RFP TITLE: DARRELL HESTER JUVENILE DETENTION CENTER SMOKE EVACUATION AND HVAC SYSTEMS UPGRADES

RFP NUMBER # 231001

Darrell Hester Smoke Evacuation and HVAC Systems Upgrades – RFQ #231001

ADDENDUM NO. 4

DARRELL HESTER
01 ENLARGED CENTRAL PLANT MECHANICAL PLAN
 SCALE: 1/4" = 1'-0"

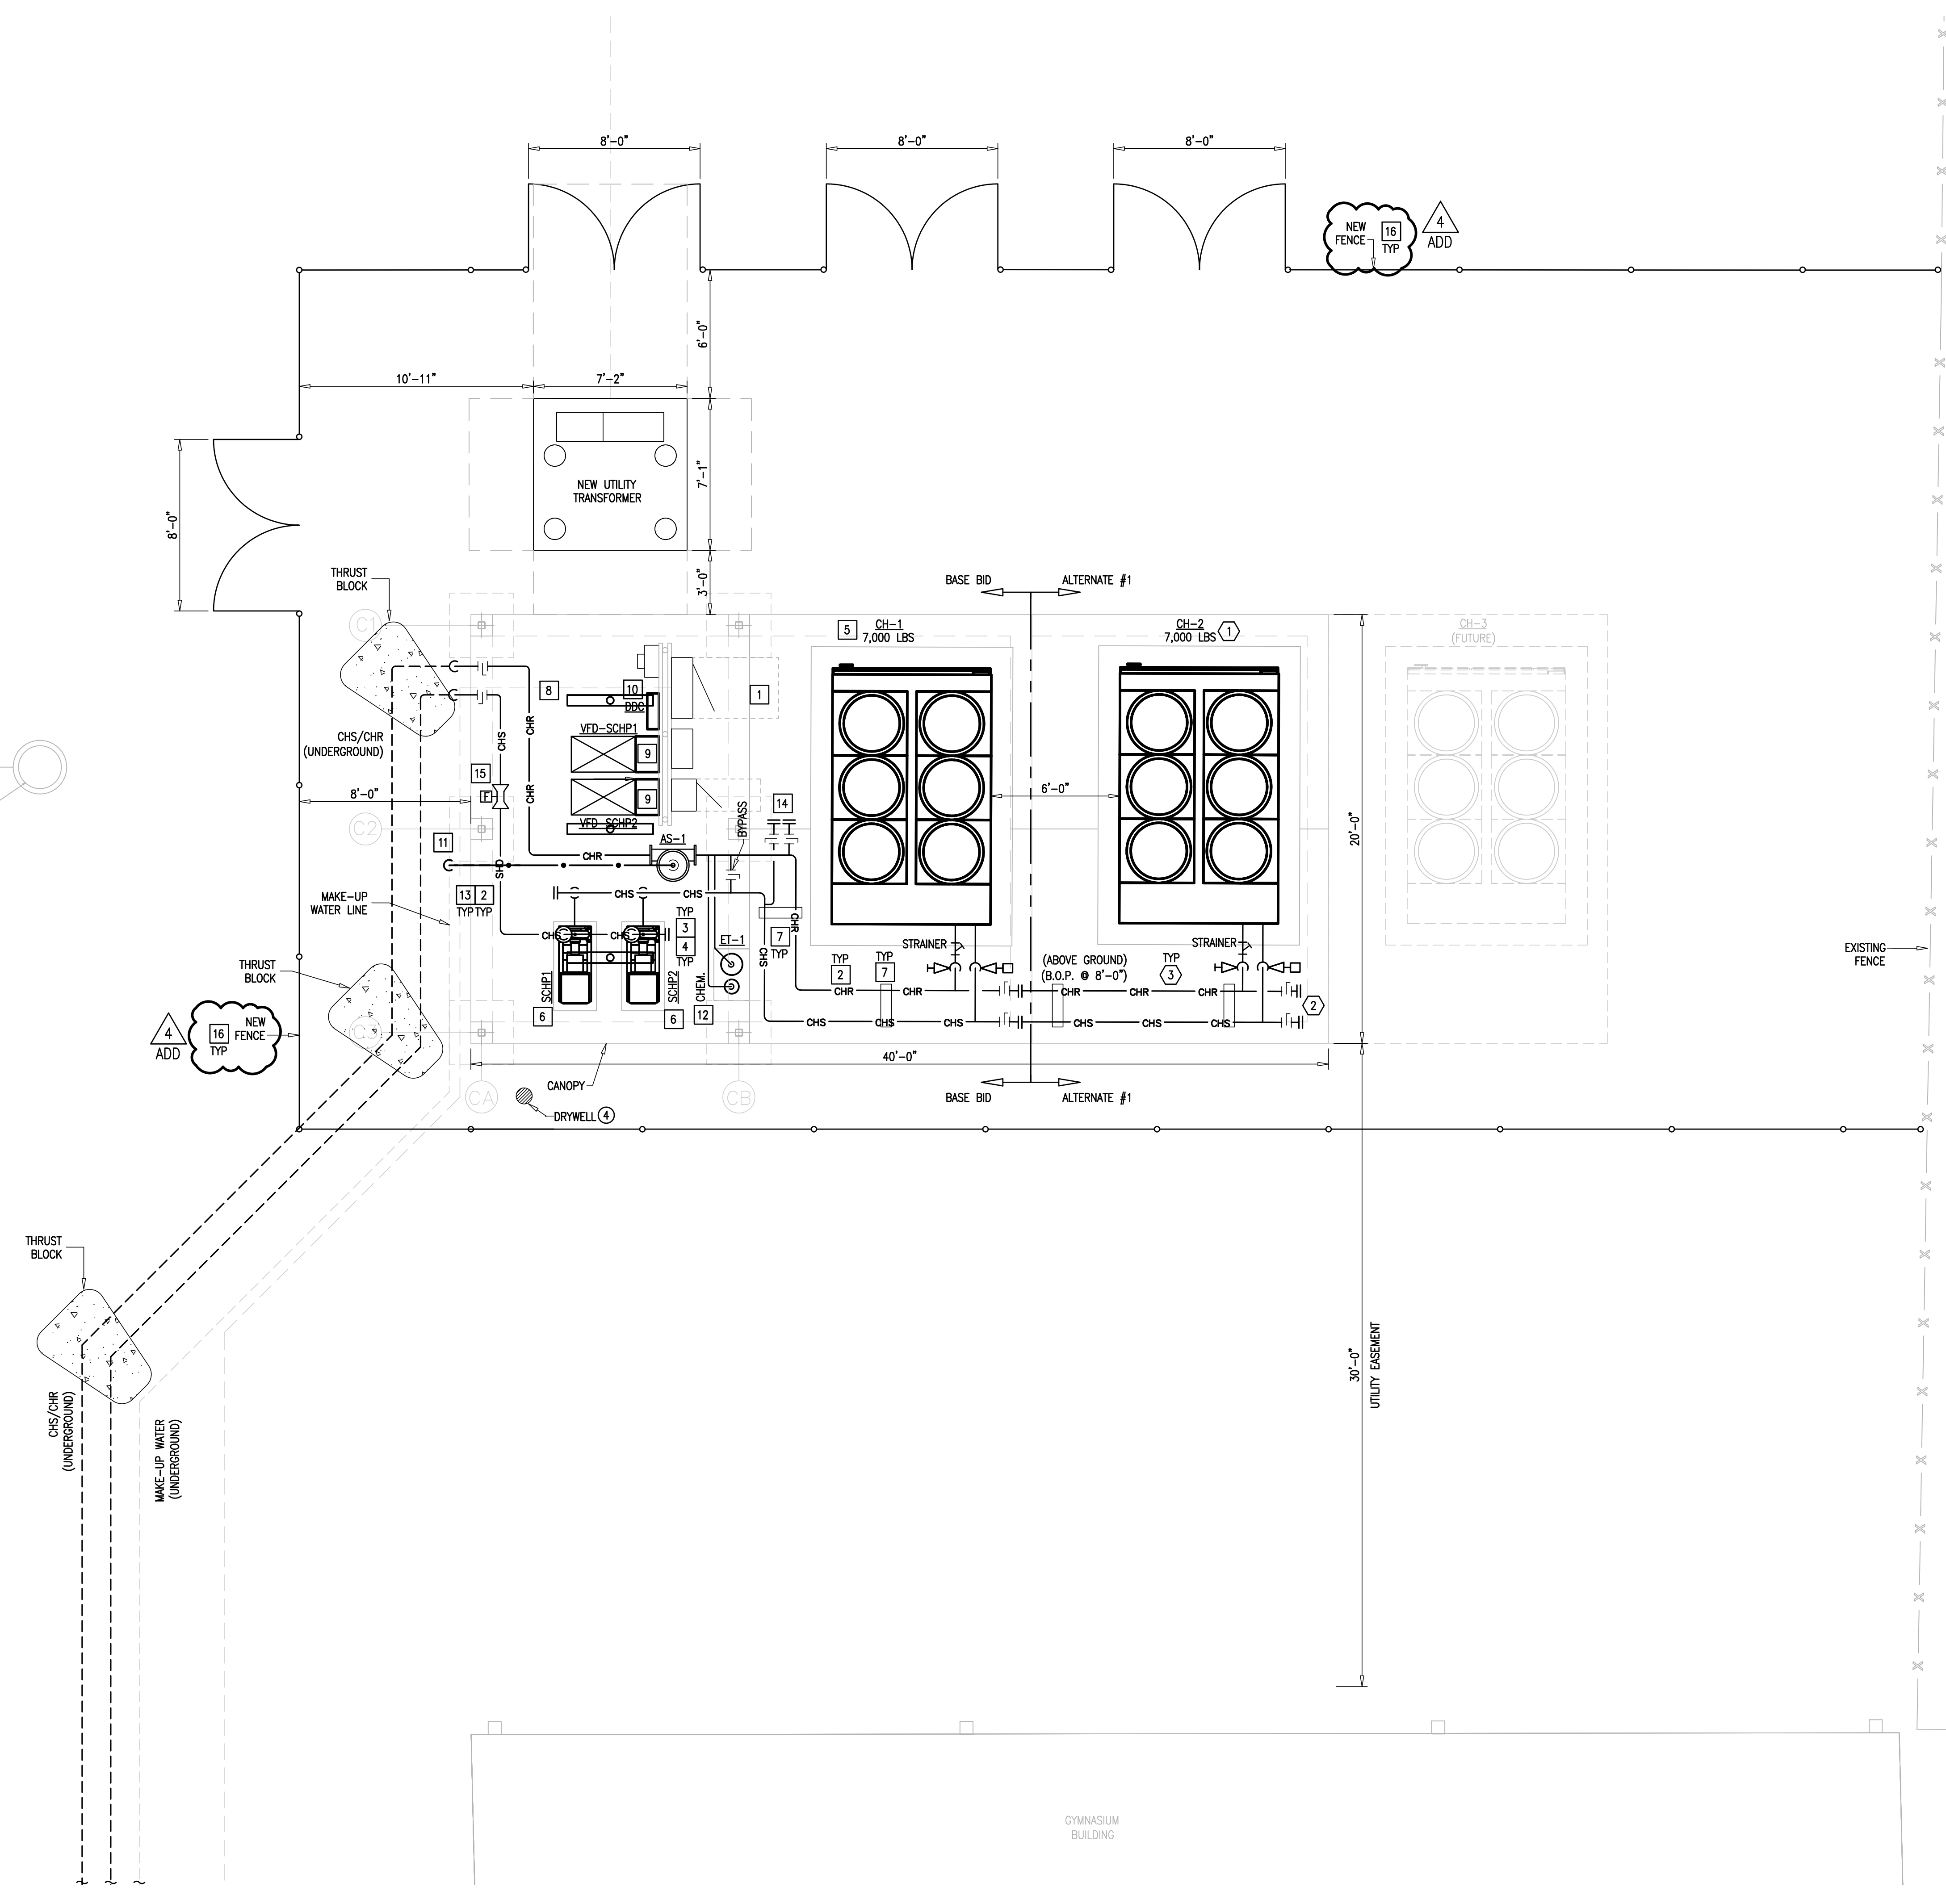
9. What is the height for the new fence and gates the encloses the New Chiller Plant.
New chain-link fence should be 8ft tall. See attached revised drawing under this same Addendum.

- 1) Sheet M4.02:
Added Keyed note. See attached sheet.
- 2) Sheet M5.01:
Revised schedule notes and names. See attached sheet.
- 3) Sheet M6.02:
Revised mechanical elevation damper. See attached sheet.

- PROVIDE NEW 8FT. TALL CHAIN-LINK FENCE AS PER SPECIFICATIONS AND DRAWINGS. CONTRACTOR SHALL INSTALL BOTTOM LOCKING DOUBLE WALL SLATS. FLAT TUBULAR SHAPE WITH INSIDE REINFORCED LEGS. COORDINATE FINAL SLAT COLOR AND FINISH WITH OWNER.

TYPICAL
 MECHANICAL ELEVATION
 03
 SCALE: 1/4" = 1'-0"

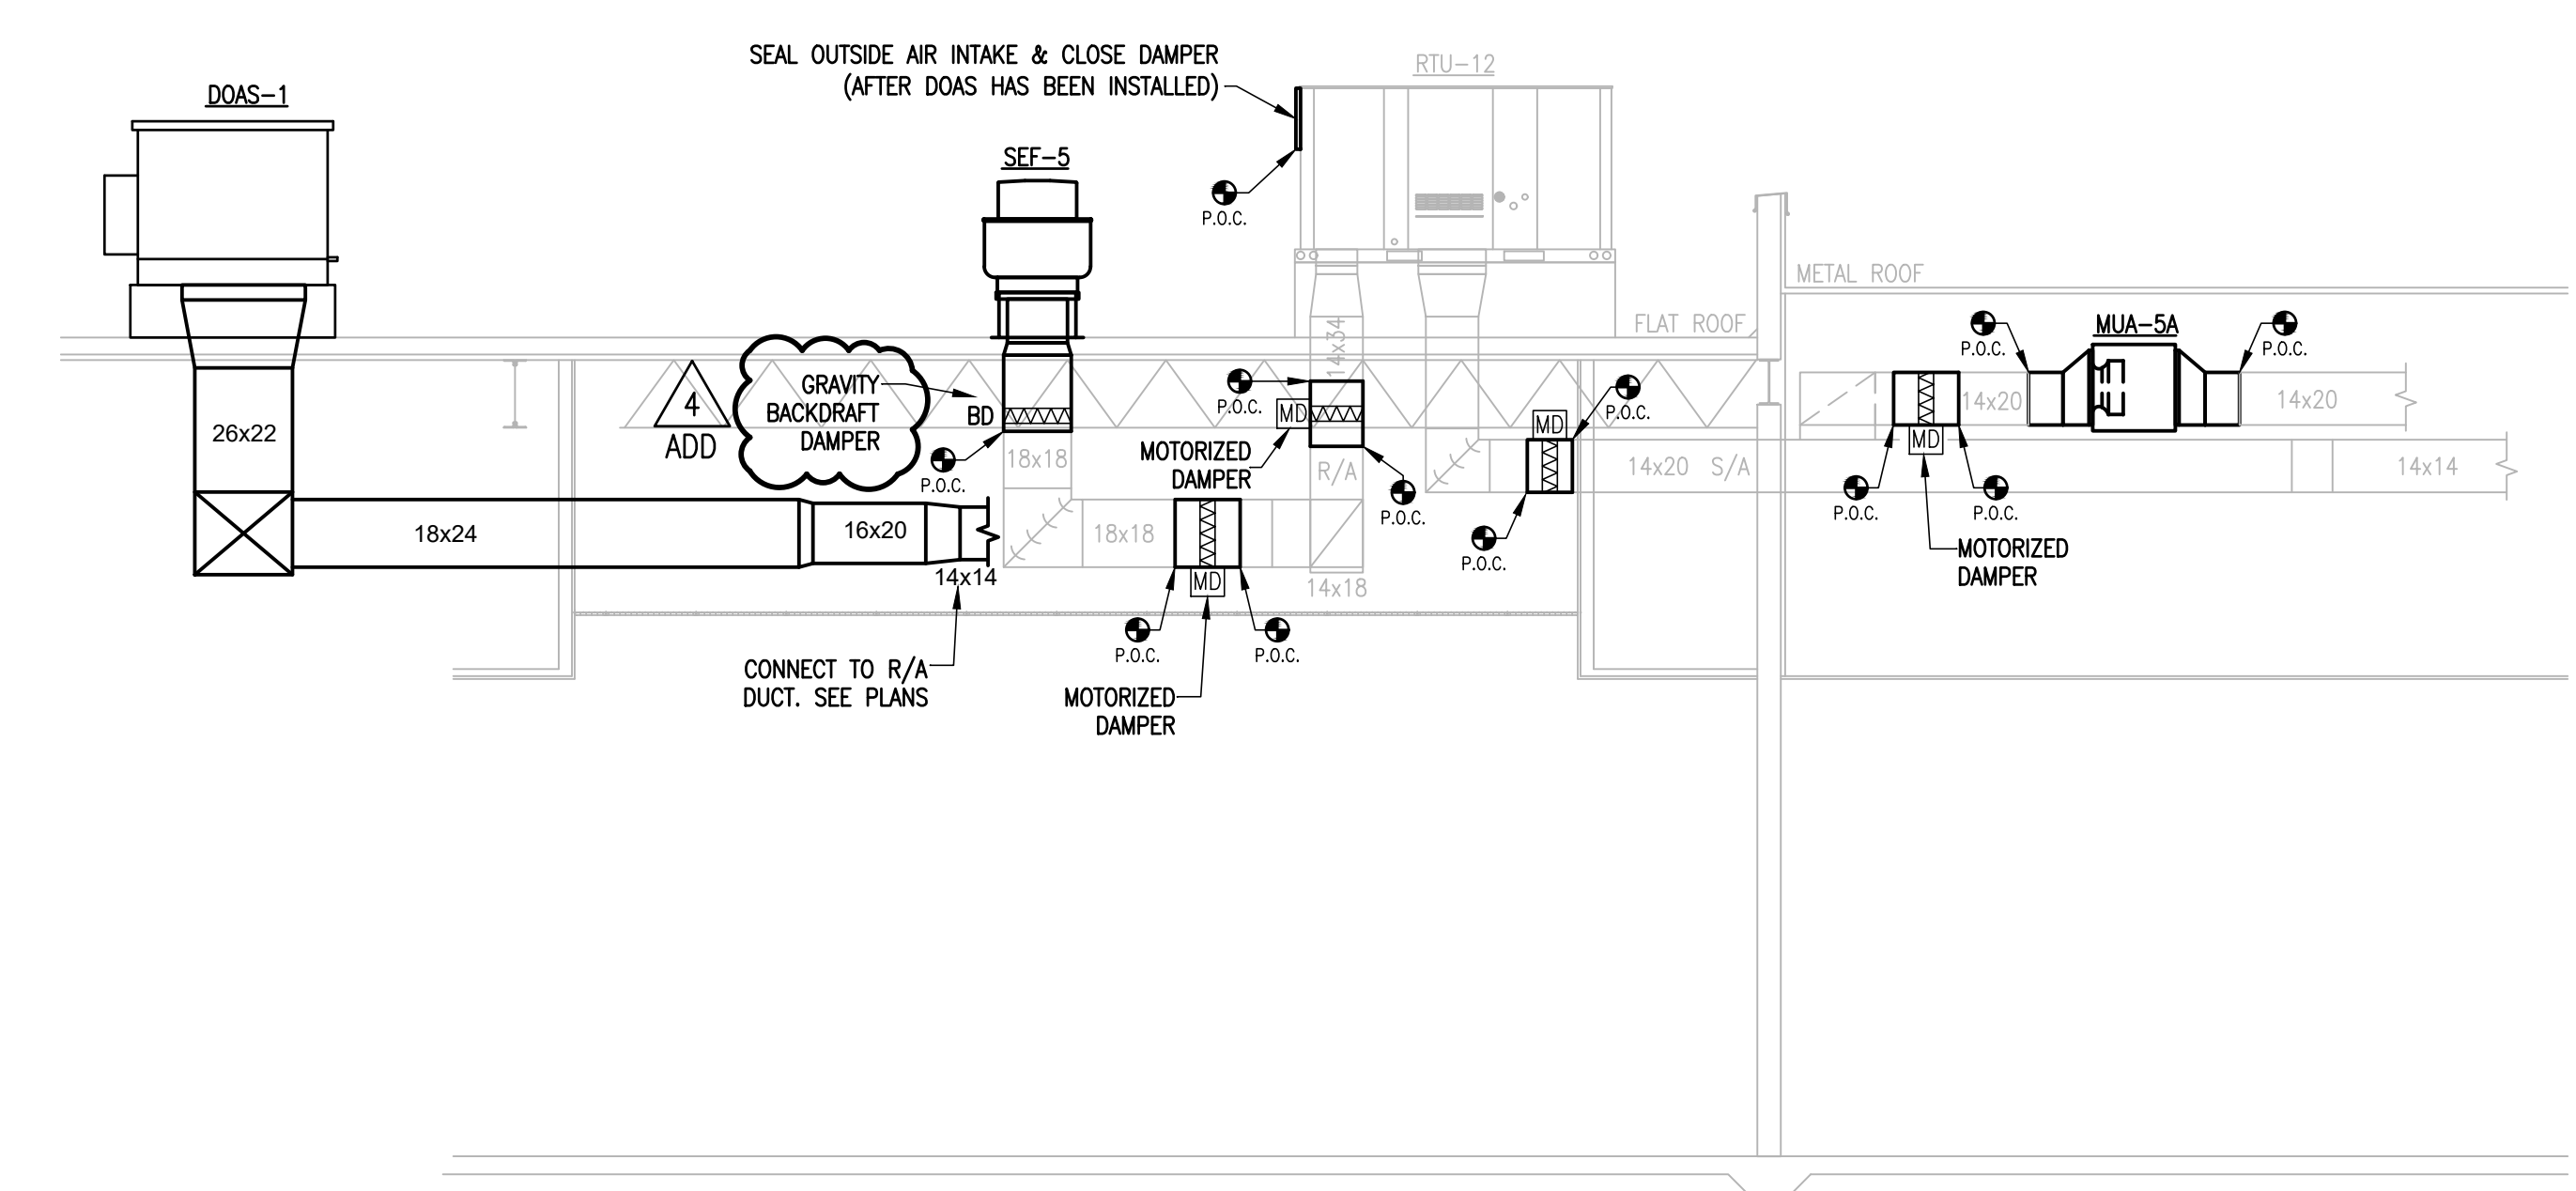
11. Detail 3/Sheet M6.02 shows both a backdraft damper and a separate control damper located within the ductwork for the smoke evacuation fans. Schedule note 2 on the “backdraft damper schedule” located on Sheet M5.01 show that backdraft dampers are to be supplied with actuators which includes the backdraft dampers for the smoke evacuation fans. Please confirm if both a motorized backdraft damper and a separate motorized control damper are required for the smoke evacuation fans.
No, one motorized and one non-motorized dampers should be supplied and installed as per drawings. Refer to sheet M6.02/03
